**U.S. NUCLEAR REGULATORY COMMISSION
REGION IV**

Report No.: 50-445/99-18
50-446/99-18

Facility: Comanche Peak Steam Electric Station, Units 1 and 2

Comanche Peak Steam Electric Station, Units 1 and 2
NRC Inspection Report No. 50-445/99-18; 50-446/99-18

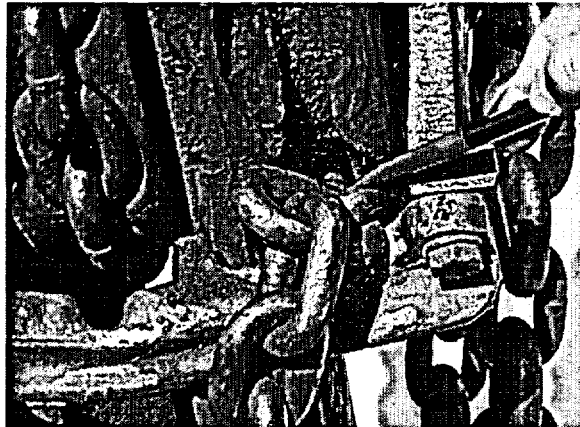
The condition of the chain hoist was unknown following the event. The licensee clearly observed that a chain link was wedged in the lower chain block between the outermost sheave and a brass guide bar across the sheaves (see photo below). It was speculated that this was all that was preventing the motor from descending further. Each of the hoist's drive trains was equipped with an electric and mechanical brake. The brakes had failed to prevent the initial drop, so it was unknown whether any of them were engaged and holding the load.

The RCP motor did not free fall during this event, since its decent was slowed by friction generated in the chain hoist. However, none of the brakes on the failed drive train were engaged and the brakes on the intact drive train were destroyed during the event, since they were insufficient to hold the load. The only thing that arrested the fall was the link of chain that lodged in the lower chain block. The postevent examination of the hoist revealed severe damage to the brass retaining bar and its threaded fasteners which

indicated that, had the chain lodged in the center of the chain block rather than the edge, the retaining bar may have failed, allowing the motor to continue to fall.
